# MHP 23025

## BUILDING PERMIT COVER PAGE

BUILDING PERMIT PLANS REVIEW	ACCEPTED AS NOTED	
	REVIEWED BY	DATE
ZONING		
PLANNING		
ARCHITECTURAL	CM	NOV 4, 2023
STRUCTURAL		
FIRE		
PLUMBING	CARD	
MECHANICAL		
PLANS REVIEW COMPLETED	CM	NOV 4, 2023

MODEL:	RIVER 6
SCALE:	3/16"=1'-0"
PROJ. No.	22-16
DWG. No.	0

**BASEMENT PLAN EL-2**  
 ZADORRA ESTATE INC.  
 CITY OF OSHAWA

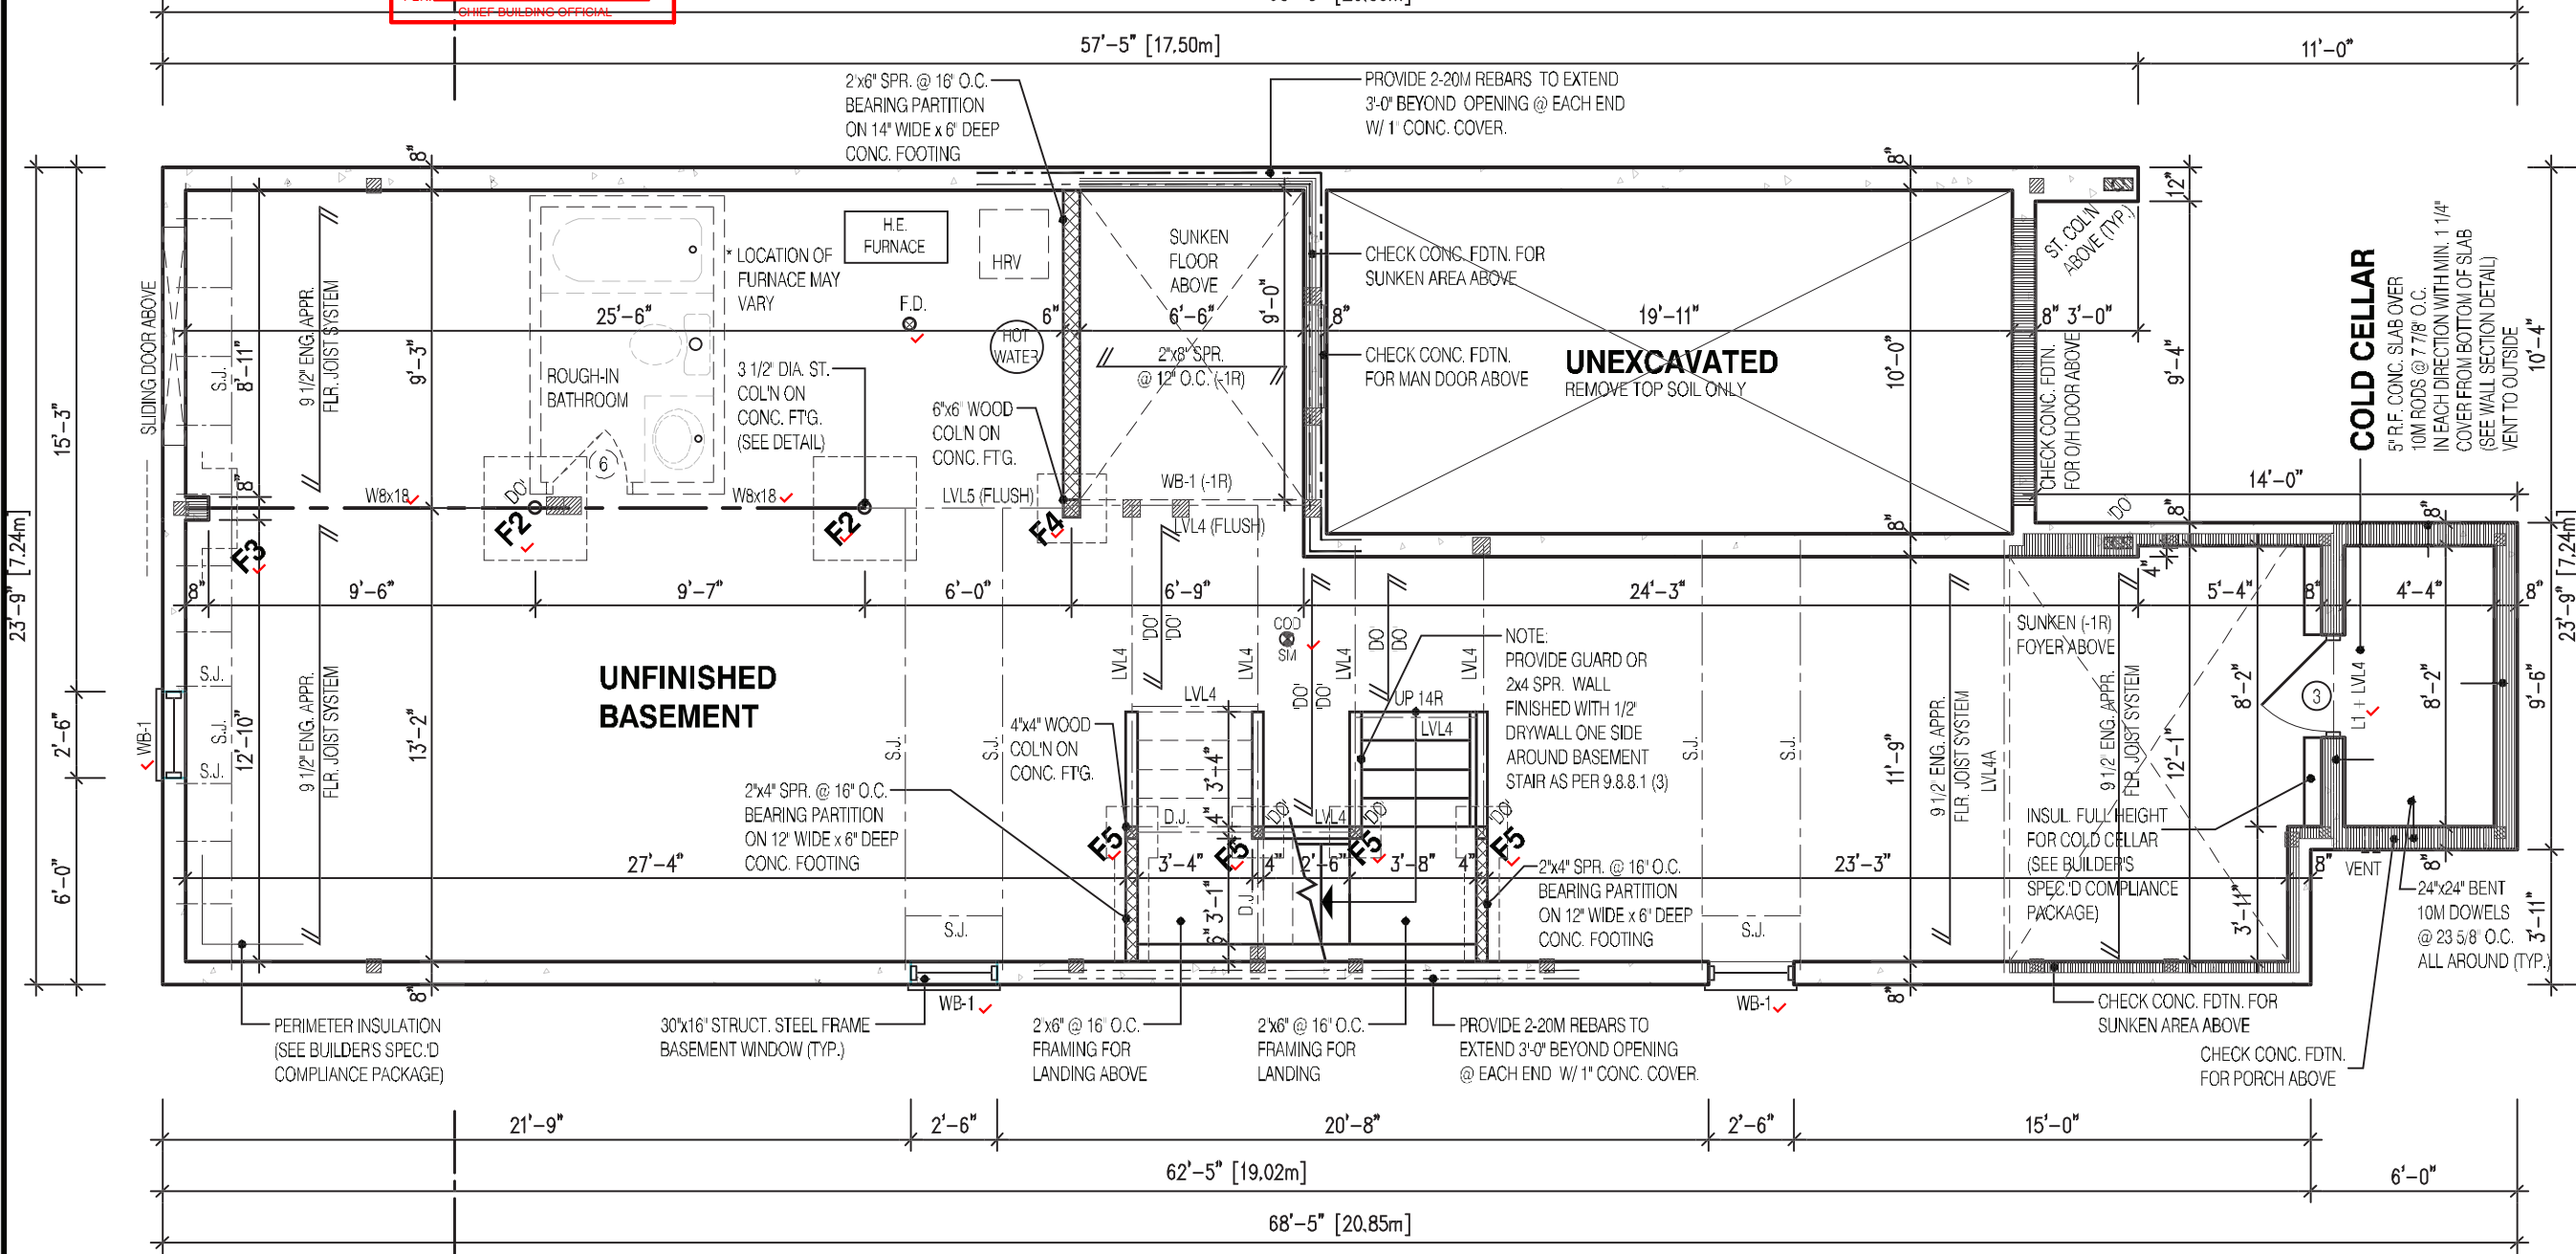
**NOTE:**  
 REFER TO SHEET NO. 0-1 FOR LINTEL, BEAMS AND DOOR SIZE

**DECK CONDITION EL 2**  
 ZADORRA ESTATE INC.  
 CITY OF OSHAWA

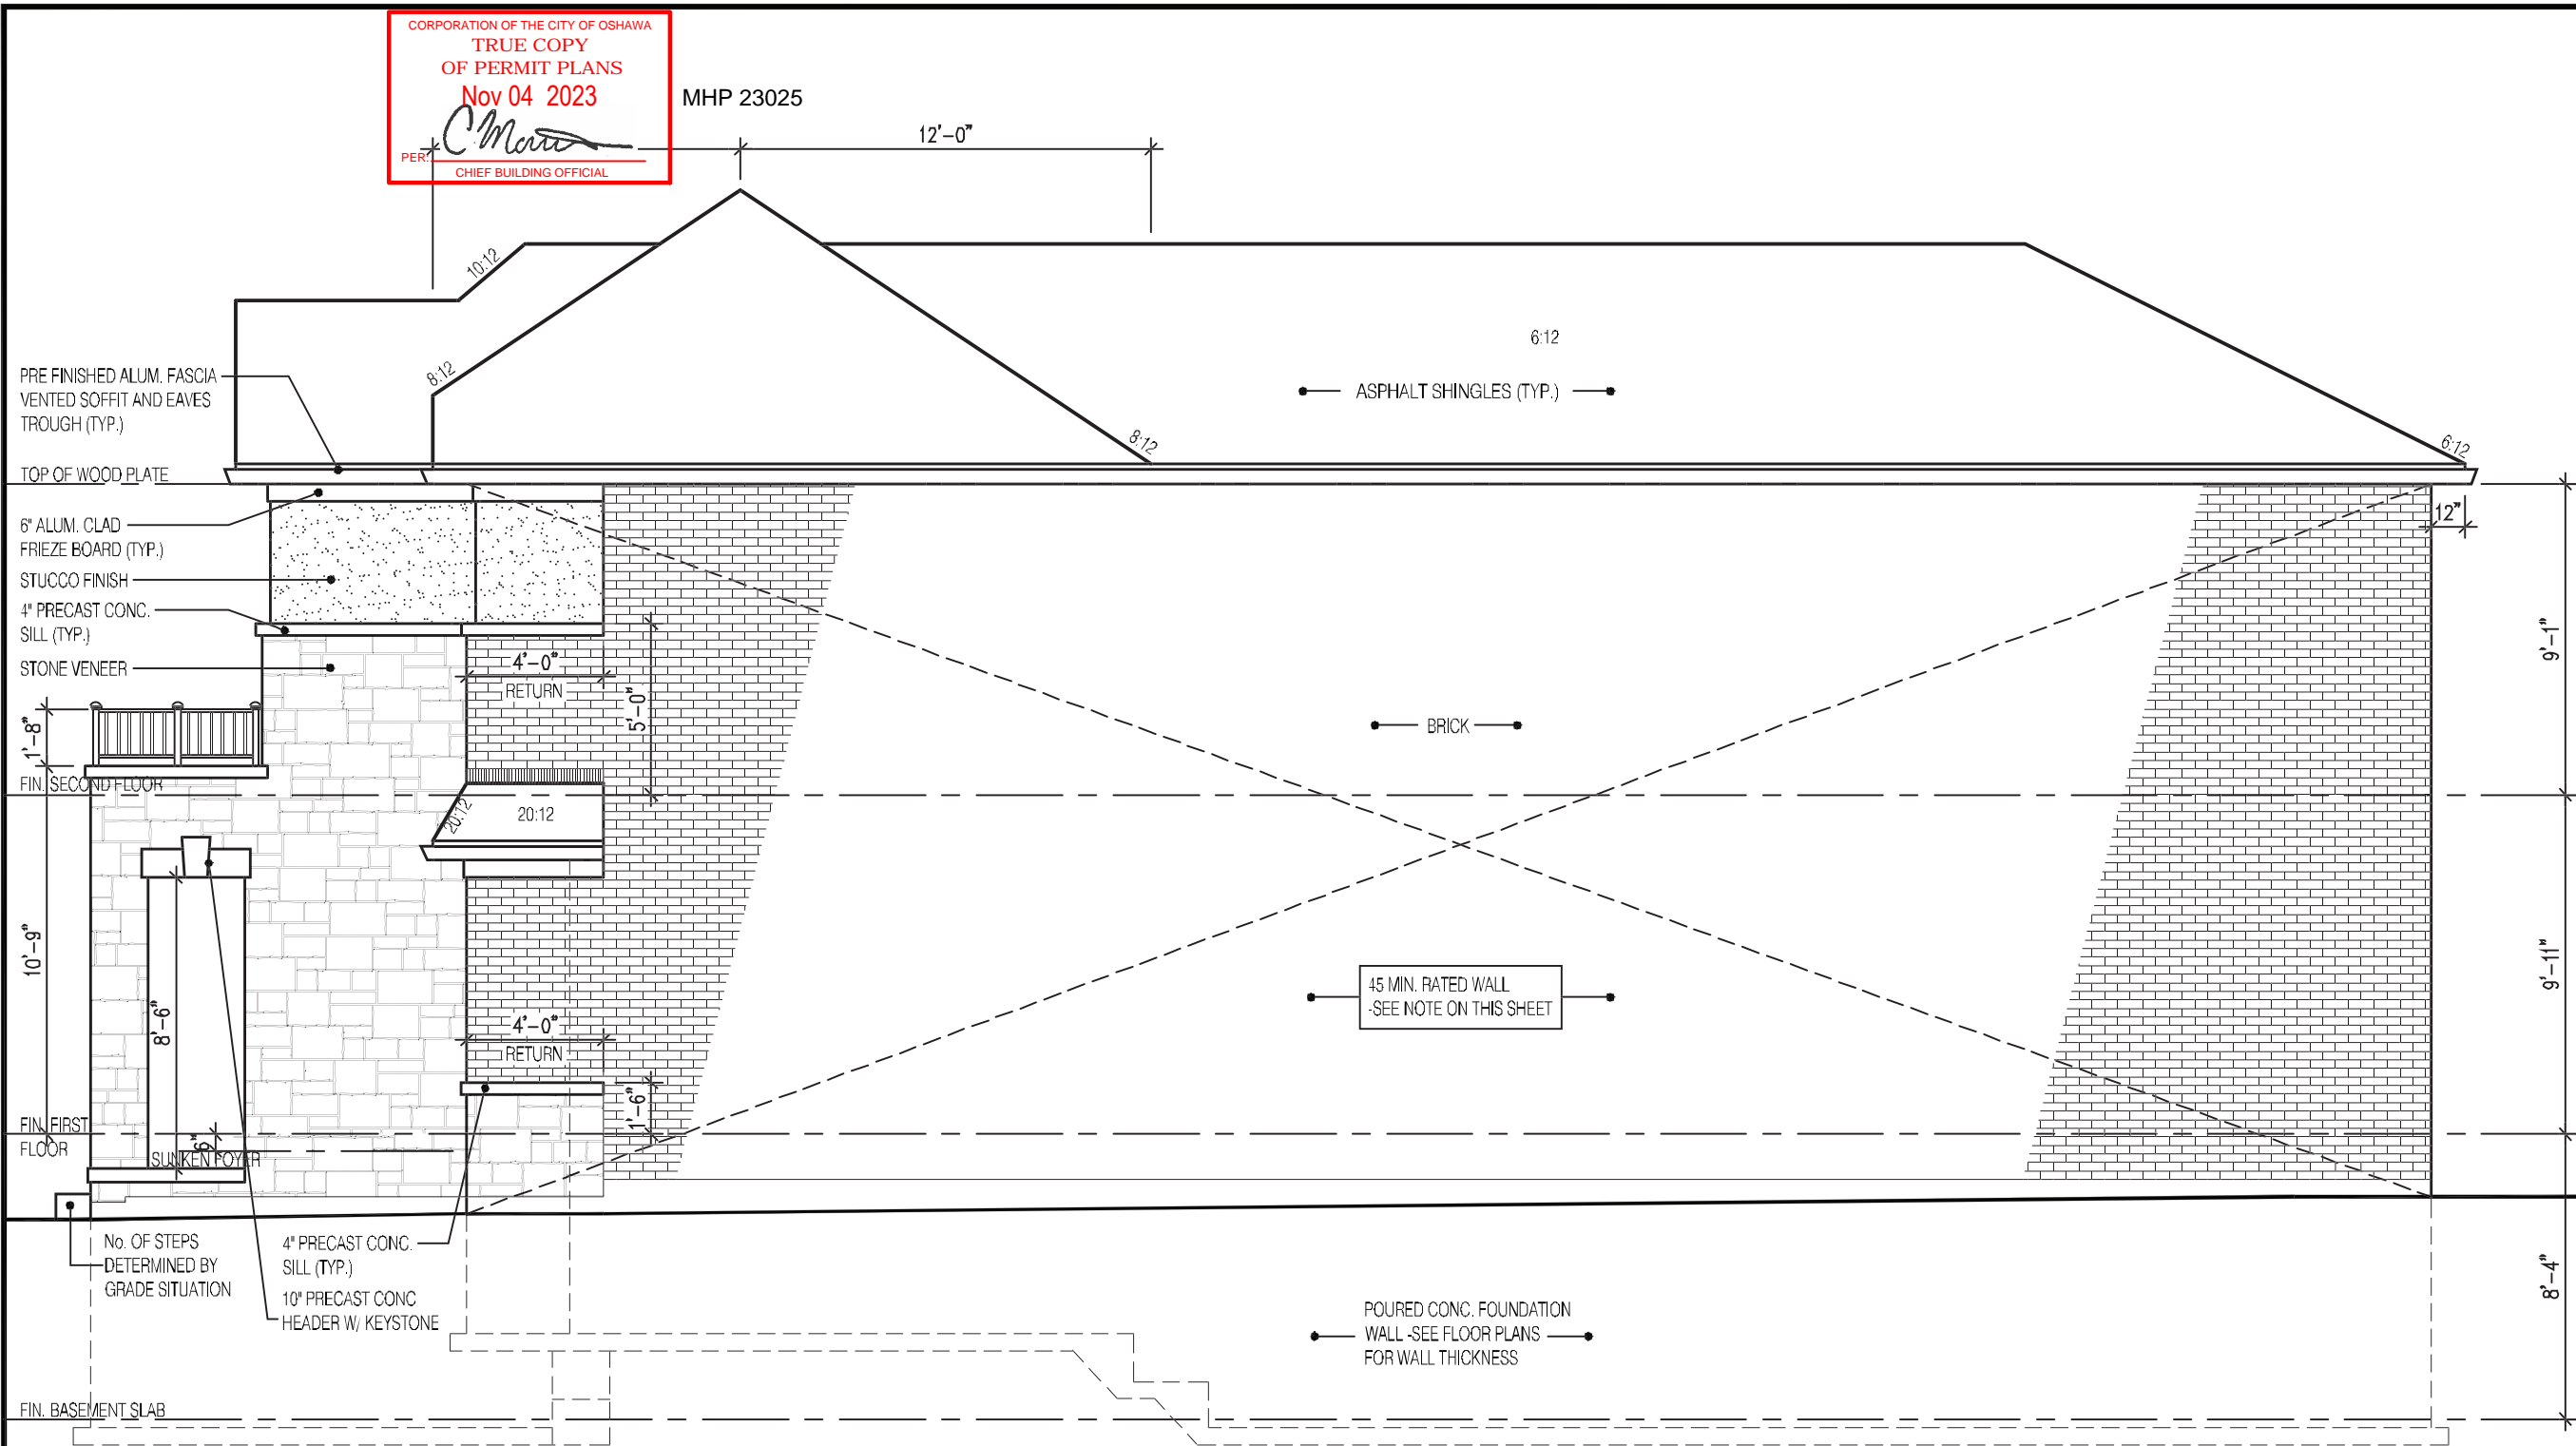
PROVIDE 15.9mm (5/8") TYPE 'X' GYPSUM BOARD BETWEEN FLOOR JOIST AT THE HEADER OR CONTINUOUSLY ALONG THE RIM JOIST WHEN FLOOR JOISTS ARE PARALLEL TO RIM JOIST TO MAINTAIN 45 MINUTE FIRE RATING.

PROVIDE A CONTINUOUS LAYER OF 12.7mm (1/2") TYPE 'X' GYPSUM BOARD (INTERIOR SIDE) INSTALLED SO THAT ALL EDGES ARE SUPPORTED, TAPED AND FILLED. SPACE BETWEEN WOOD STUDS TO BE FILLED WITH PREFORMED MINERAL FIBRE INSULATION WITH A MASS OF NOT LESS THAN 1.22 Kg/SQ.M. AND MUST FILL AT LEAST 90% OF THE CAVITY THICKNESS. THE TYPE 'X' & INSULATION MUST BE RUN CONTINUOUSLY BEHIND ALL INTERSECTING PARTITIONS, MECHANICAL CHASES, BATHTUBS, SHOWERS, ETC. ENSURE INSULATION & TYPE 'X' IS INSTALLED IN GARAGE EXTERIOR WALLS
